**Subject: Mod 8 - Link Road Realignment Adjustment (SSD-5170-Mod-8)**

## Attachment 1 - CPHR Comments

### Mod 8 - Link Road Realignment Adjustment (SSD-5170-Mod-8)

**Image 1** - No Targeted Flora Survey within the southeastern corner of the subject site

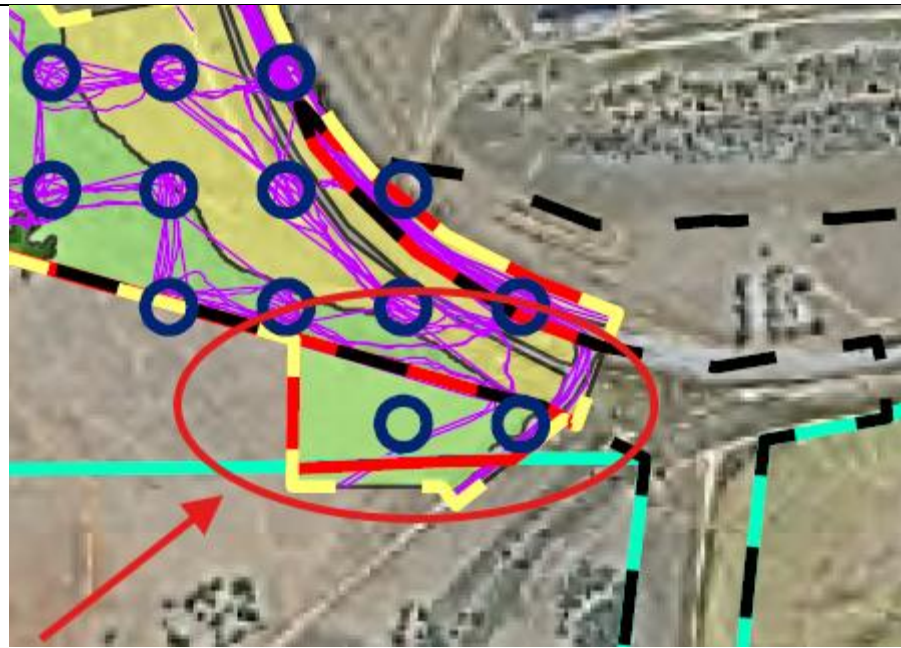
6.	<b>Targeted flora and fauna searches have not been completed in accordance with the BAM, Threatened Biodiversity Database Collection (TBDC) and relevant survey guidelines</b>	<p>Targeted flora searches have not been completed in accordance with the BAM. Examples include:</p> <ul style="list-style-type: none"> <li>• For <i>Diuris tricolor</i> – endangered population, and <i>Prasophyllum sp. Wybong</i>, the TBDC states ‘<i>Survey in Sep. If not found during survey, survey again in Oct.</i>’ No survey has occurred for these species in September, therefore the survey effort is not in accordance with the BAM.</li> <li>• For <i>Prasophyllum petilum</i>, <i>Prasophyllum sp. Wybong</i>, and <i>Pterostylis Chaetophora</i> the recommended survey period reported in the BDAR (Table 3) is incorrect. Please update Table 3 of the BDAR with the correct recommended survey periods for each species.</li> <li>• No survey for any flora species has been completed in the south-eastern corner of the subject site. See <b>Image 1</b> below.</li> </ul>

- provide adequate justification and evidence to ensure survey for threatened flora and fauna has been completed in accordance with the BAM, TBDC and relevant survey guidelines. Alternatively, seek concurrence from BOS Help Desk or provide justification e.g. citation of peer-reviewed literature of survey method, effort and timing if the approach differs from the department’s taxa-specific survey guides, or where no relevant guideline has been published, or presence can be assumed, or an expert report can be provided.

**Image 2** - No Targeted Fauna Survey within the southeastern corner of the subject site

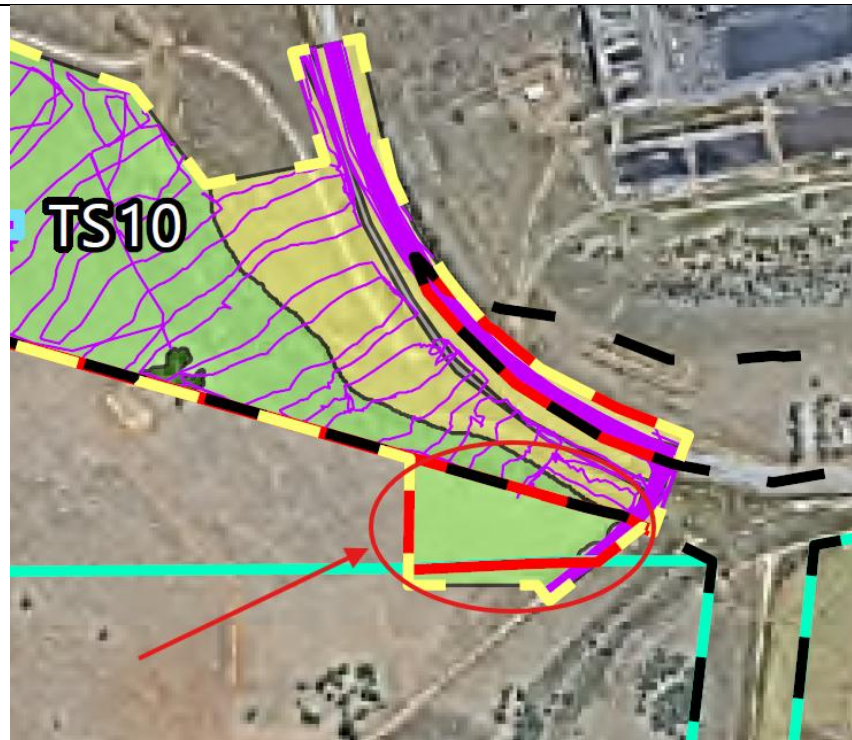
<p>the TDBC and other relevant survey guidance, and either complete further survey, or alternatively seek an expert report or assume presence.</p> <ul style="list-style-type: none"> <li>• Barking Owl, Powerful Owl and Masked Owl – the BDAR does not clearly identify when the 6 nights of call playback occurred, and which calls where played. The spatial data also fails to provide this information. The method does not state whether the volume of calls was gradually increased. No details are provided on which hollow bearing trees were searched and when. The BDAR needs to clearly detail survey effort.</li> <li>• Common Planigale – survey effort does not meet the survey requirements of the BAM 2020. Only 5 pitfall trap arrays were set up across the site, which is not BAM compliant. The TDBC requires at least 10 pitfall arrays per 10 ha of habitat. Please refer to the TDBC and other relevant survey guidance and complete additional survey effort for this species. Alternatively seek an expert report or assume presence.</li> <li>• Koala – BDAR states that subject land comprises of approximately 40 ha of suitable habitat for Koala. The incorrect grid spacing and survey effort have been applied. The Koala (<i>Phascolarctos cinereus</i>) - <i>Biodiversity Assessment Method Survey Guide</i> states that 150 m grid spacing should be applied to areas of suitable habitat &lt;50 ha, and that approximate number of hectares needs to be divided by 2.25. The BDAR states 40 hectares of habitat and therefore approximately 18 Spot Assessment Technique (SAT) sites are required, instead of the 8 completed. In terms of spotlighting the BDAR does not provide information that survey effort complied with the BAM. The guide states 2 x 200m transects are required for every 5 ha of suitable habitat. Given there is 40 ha of suitable habitat, then 16 x 200 m spotlighting transects are required. Update the BDAR to include this information as per the guide and provide spatial data to confirm survey effort.</li> <li>• Grey-headed Flying-fox - survey effort described in the BDAR currently does not meet the requirements of BAM. Surveys must be undertaken and survey methodology provided, as per the Threatened Bat Survey Guide.</li> <li>• CPHR notes that no survey for any fauna species has been completed in the southeastern corner of the subject site. See <b>Image 2</b> below.</li> </ul>
